PLANNING COMMISSION MEETING

1. **APPLICANT: NOR AM INVESTMENT, LLC (Z2015-100)**

REQUEST: TEXT AMENDMENTS TO THE LAND USE & DEVELOPMENT REGULATIONS FOR THE BADGER MOUNTAIN SOUTH MASTER PLANNED COMMUNITY.

TO: PLANNING COMMISSION
FILE NO.: Z2015-100

Parking Placement Diagram (Plan View)

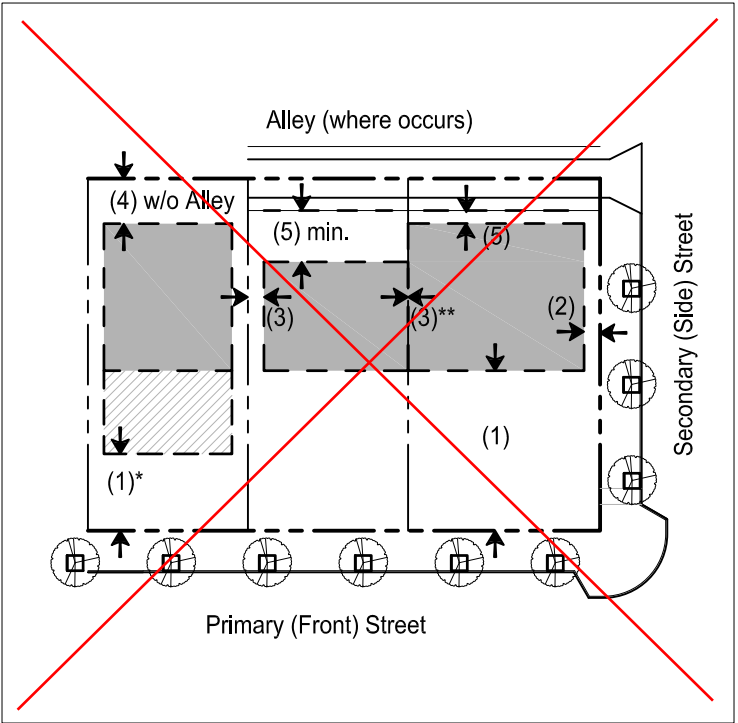
- a. **Parking Placement**
- ~~On-grade parking (enclosed or unenclosed) is allowed only in the shaded area as shown in the parking placement diagram.~~

Building Placement Diagram (Plan View)

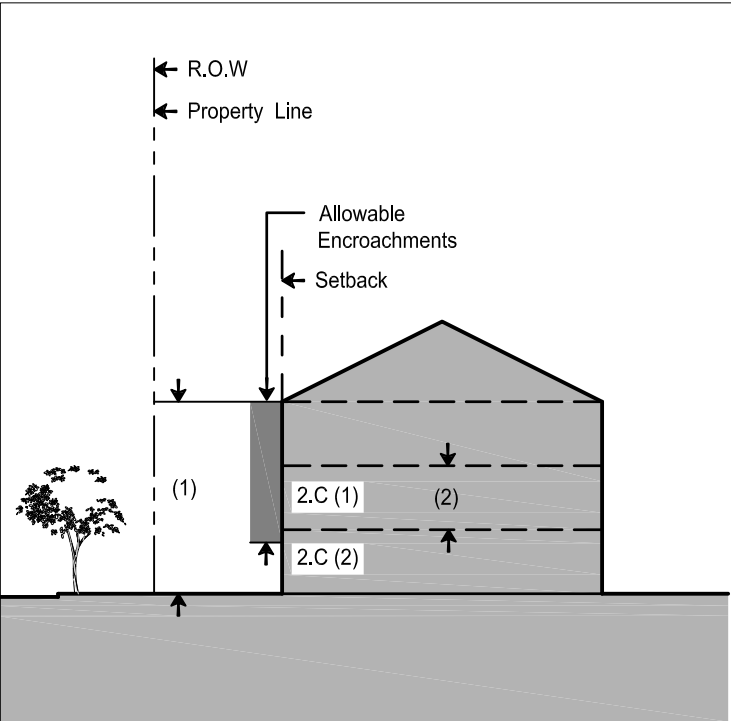
- a. Setbacks** (as measured from the property line)
- Buildings shall be placed within the shaded area as shown in the building placement diagram. ~~Parking garages shall be placed per item 4a. Parking Placement.~~ **35 ft.**

- (1) Front Build-to-Line: 15 ft. min.; ~~25 ft. max.~~ *
 - * Maximum setback does not apply to lots => 1/4 acre.
 - (2) Side Street Setback: 10 ft. min.

Building Profile Diagram (Section View)

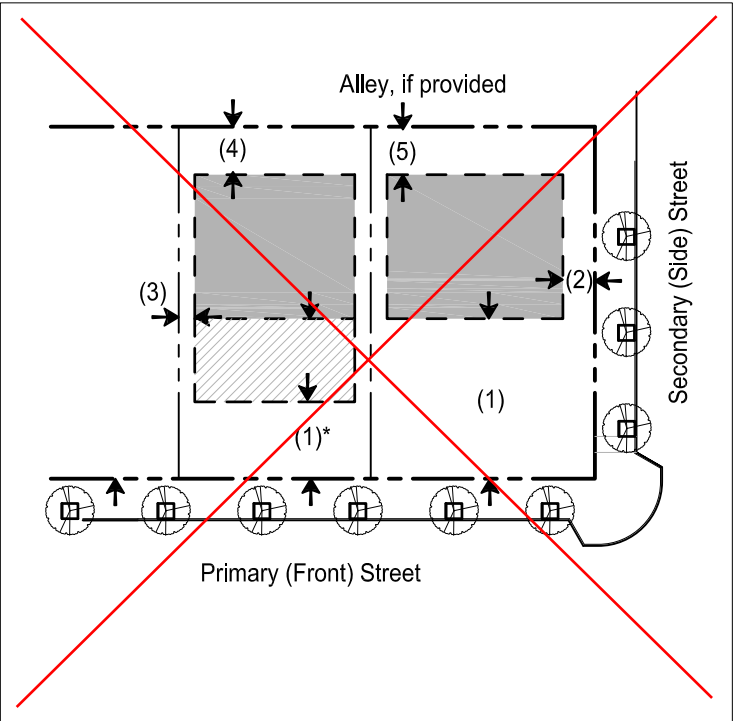
- a. Building Height/Stories**
- (1) Maximum Height: ~~3 Stories~~ **30 ft. as defined in RMC.**
 - (2) ~~Story Height: 8 ft. minimum, 12 ft. maximum.~~
